Comments Addressing

The Role of Carbon Capture and Sequestration in
the Environmental Protection Agency's Proposed

Standards of Performance for Greenhouse Gas Emissions From New Stationary
Sources: Electric Utility Generating Units

Submitted to:
The Environmental Protection Agency Science Advisory Board

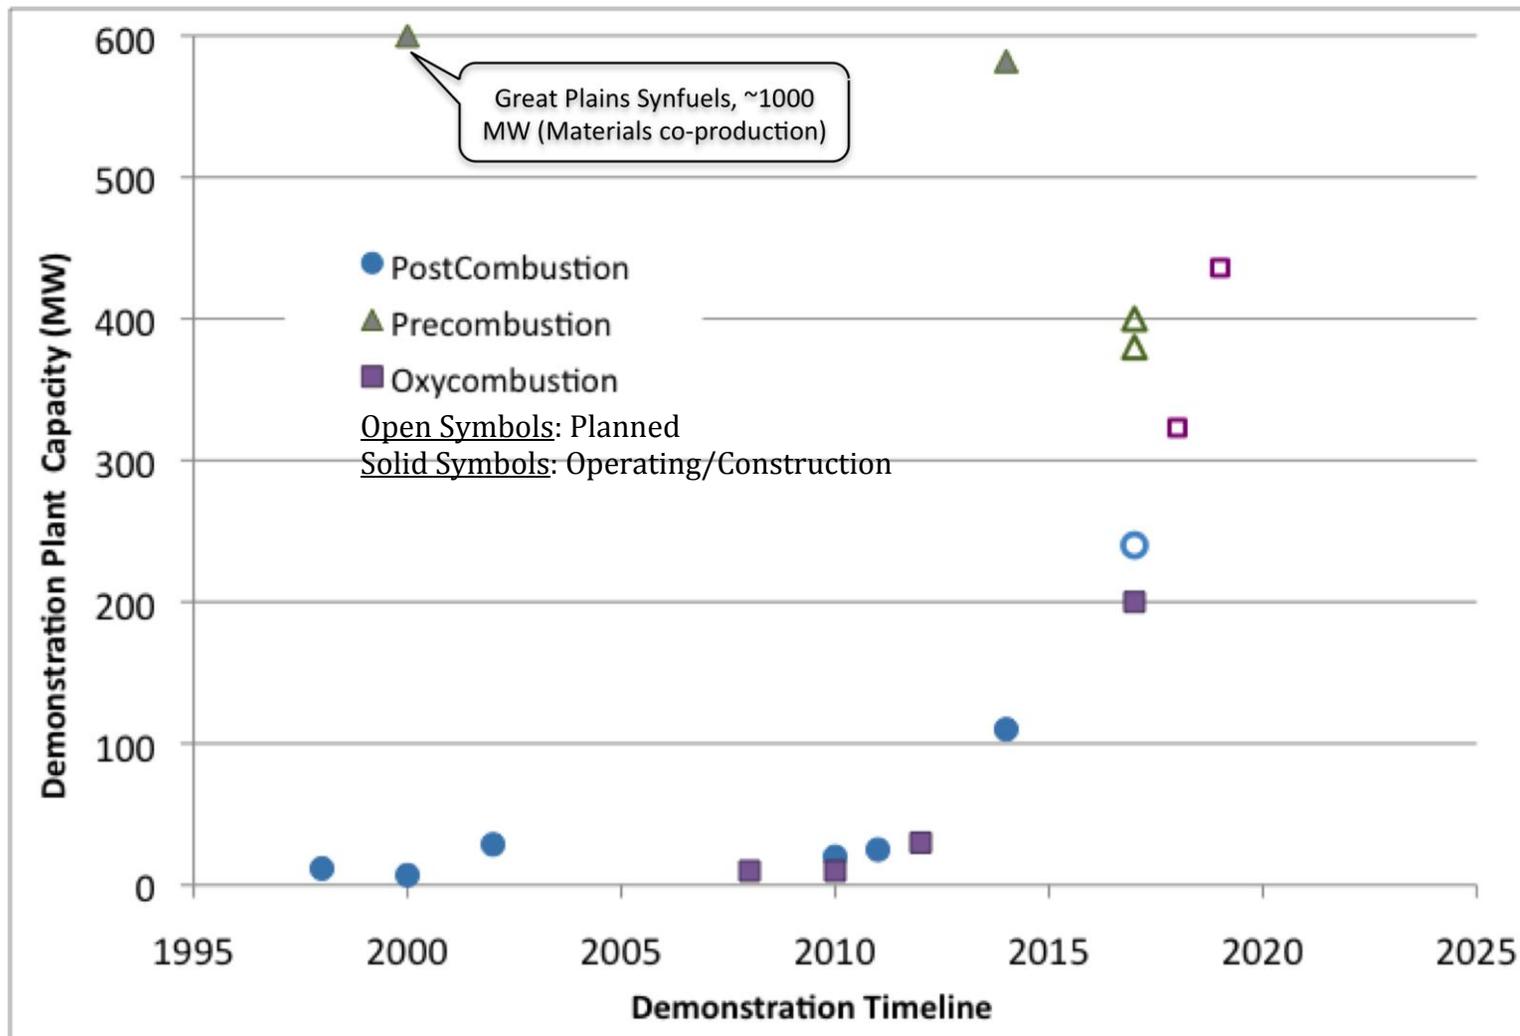
A similar level of experience is required to designate CCS as BSER. The attached figure depicts a timeline for key pilot, demonstration, and early commercial tests that could determine CCS feasibility in the U.S. The timeline shows there are only four units greater than 200 MW that are either operating or under construction from which to demonstrate CCS feasibility. Significant CCS experience on large units does not accrue until about 2017-2018 - implying commercial design data will not be available around 2019-2020; even these results will be limited in scale and scope. The timeline shows more projects planned but financing not complete (e.g. open symbols). In summary, the timeline shows by 2020 only a limited number of demonstrations will be available from which to derive design rules.
